Establishment Inspection ReportGenzyme Corporation

Framingham, MA 01701-8861

FEI: **1220423**EI Start: 7/18/2022
EI End: 7/25/2022

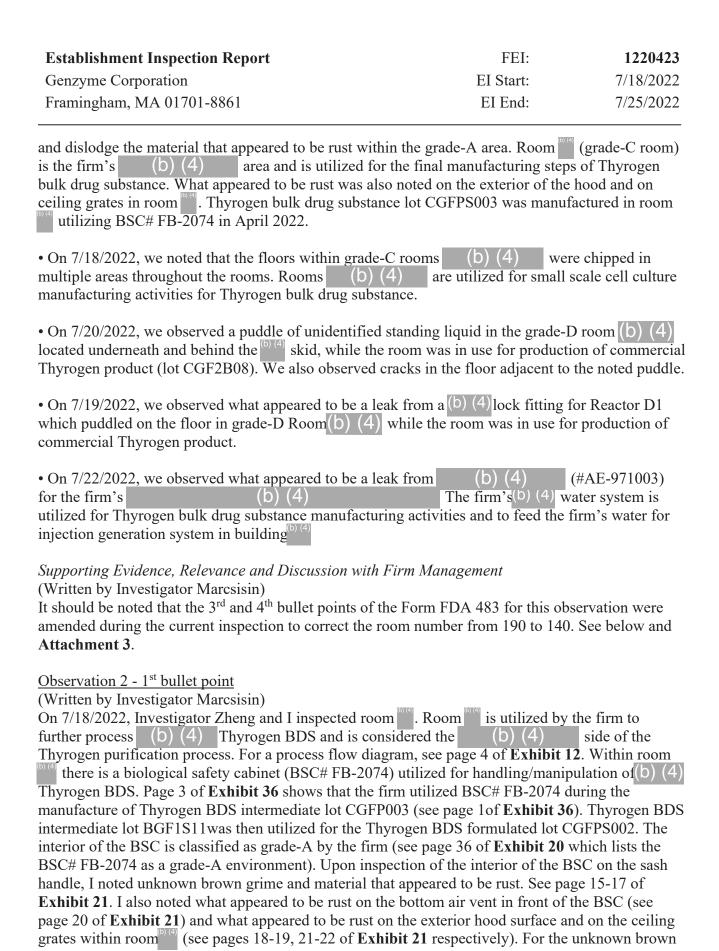
The firm does not properly maintain building which is utilized for Thyrogen bulk drug substance manufacture. During the current inspection, the following items were noted:

• On 7/18/2022, we noted what appeared to be rust on the interior of the sash handle within the grade-A area for biological safety cabinet (BSC# FB-2074 in room Telescope and Telescope area for biological safety cabinet (BSC# FB-2074).
